DRAWING AMENDMENTS

REMARKS

Applicant has carefully reviewed the Official Action dated September 20, 2005 for the above identified patent application.

Corrections PCT/SE2003/001258 WO 2004/014682 2/6 OCT 2 6 2005 PATRADEMAN F192 16 30 1731 32 F195 34 30 17 33 31

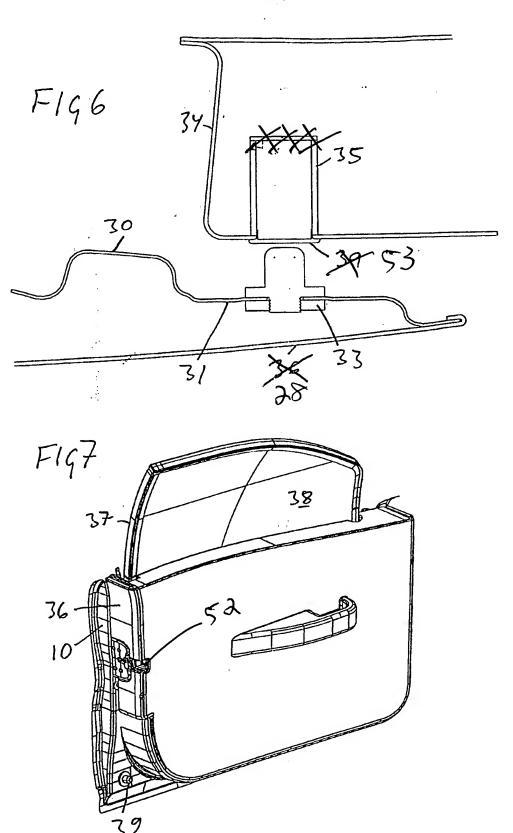
At page 2, paragraphs 1 and 2 of the Official Action, the Examiner has objected to the original drawings. In response to these objections, Applicant has filed Replacement Sheets making the appropriate corrections. The reference numeral 36 in Figures 5 and 6 has now been replaced by reference numeral 28, to conform the drawing to the disclosure at page 3, last paragraph, line 1, and page 5, first full paragraph, of the original specification. Figures 8 and 9 have been revised to add the omitted reference numerals noted in the Official Action. (Reference numerals 39,

Figure 7 has been revised to add reference numeral 52 to designate a lock, and the specification has been revised at page 5, second full paragraph, line 8 to recite "lock 52" to conform to the reference numeral added to Figure 7 as designating the lock. Additionally, reference numeral 39 in Figure 6 has been changed to 53 (and the specification has been amended accordingly at page 5, first full paragraph, line 2), since reference numeral 39 has been used to designate a different element (bolt 39 in Figure 8, described at page 6, last paragraph, line 2, of the specification).

At page 3, paragraph 3 of the Official Action, the Examiner has raised certain formal objections to the specification. In response to these objections, Figure 6 of the drawings has been revised to remove the bottom of the sleeve 35, to conform to the disclosure at page 5, line 3 of the original specification. As noted above, the cover illustrated in Figure 6 and disclosed at page 5, line 4 of the specification, is now designated by reference numeral 53.

Marked Gay Showing Cornetions
WO 2004/014682

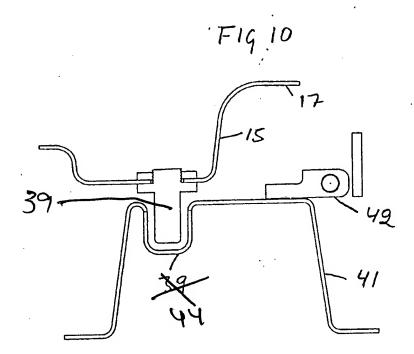
Although not mentioned in the Official Action, Figure 8 has been revised to include a reference numeral 51, to conform to the disclosure at page 7, lines 1 - 2 of the original specification; and Figure 10 has also been revised to designate the bolt as reference numeral 39 and the sleeve as reference numeral 44 to conform to Figures 8 and 9 of the drawings and to page 6, last paragraph of the specification.

The objection to the identification of the "lock" as reference numeral 39, at page 5, line 15 of the Specification, has been corrected, as noted above, by adding reference numeral 52 to properly designate the lock illustrat revising the specification to refer to the new reference numeral 52 as designating the lock illustrated in Figure 7.
